**KIF DCN KIF-05-1090-R0 (CLOSED) for Unit 1-9 (PCN KIF530)**

### KIF530 (French Drain): Drawings for 100% Design Review Meeting pre-Haber, Stanley M.

5. Authorizing Documents		KIF530					
6. Requested Change or Problem Statement		The existing ash dike for the dredge cell requires restoration in order to place the dredge cell back into production. (See Block 6 continuation)

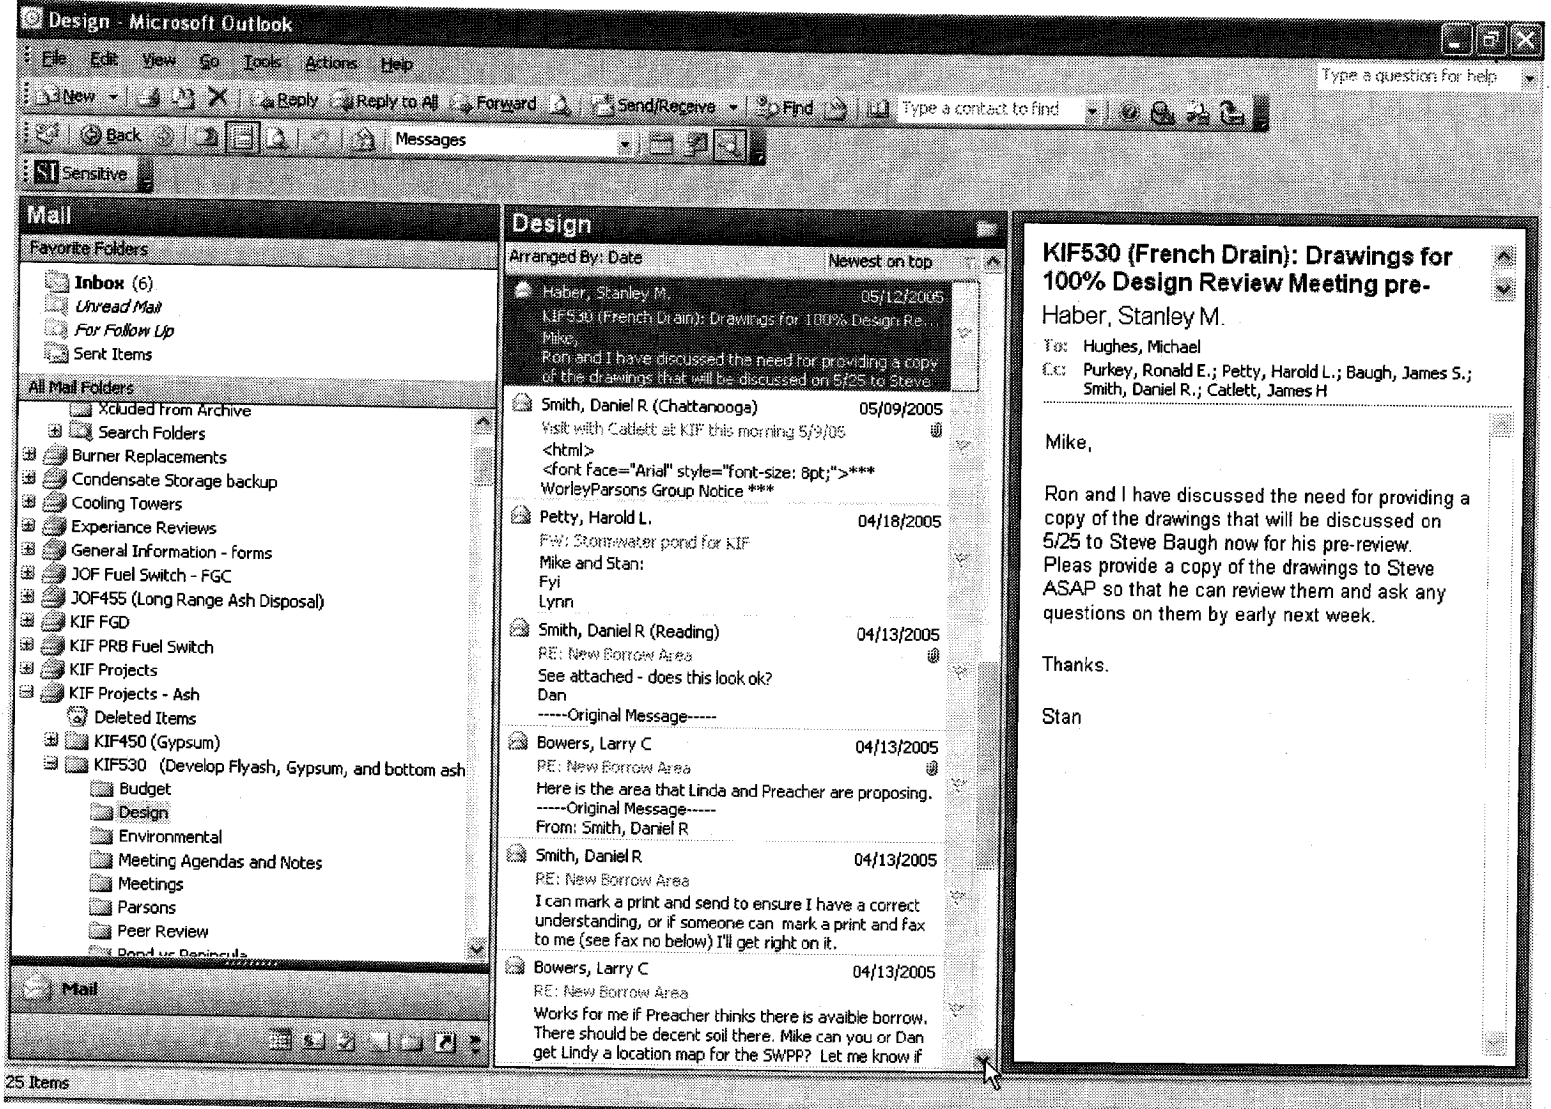
Here is one more change. We are still in the process of checking these drawings. I want to lower the drain at the toe 2 ft. This will add 1000 tons of #57 stone as well. Please see attached sketch, and call me if you have any questions.
